## Staff Report

**To:** City Council  
**Prepared by:** Amy Tweeten, AICP, City Planner  
**Report:** August 26, 2022  
**Meeting:** September 7, 2022  
**Item:** PS22-0002: Boyer Farm Estates Phase II Preliminary Plat - Public Hearing

Figure 3 - Preliminary Plat

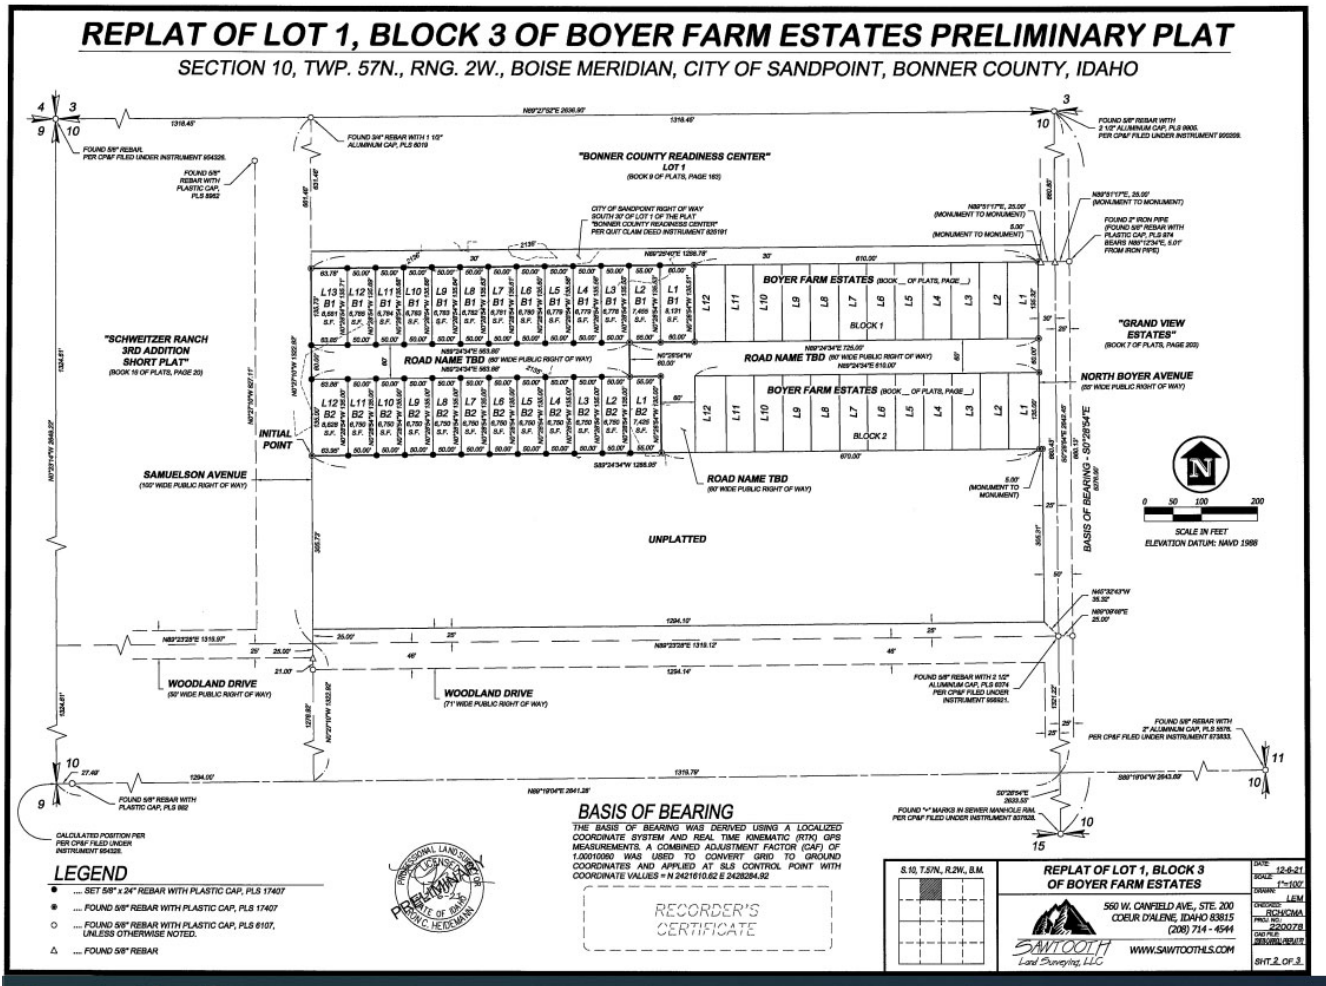
Section 10-1-6-A-5 states that block lengths shall be between 300 and 600 feet and the proposed block length is 619 feet. However, given the property orientation, if an additional cross street were created, the applicant would not be able to meet both the minimum and maximum block lengths. As the full length of the street is approximately 1,300 lineal feet, the acting city engineer finds the layout acceptable.
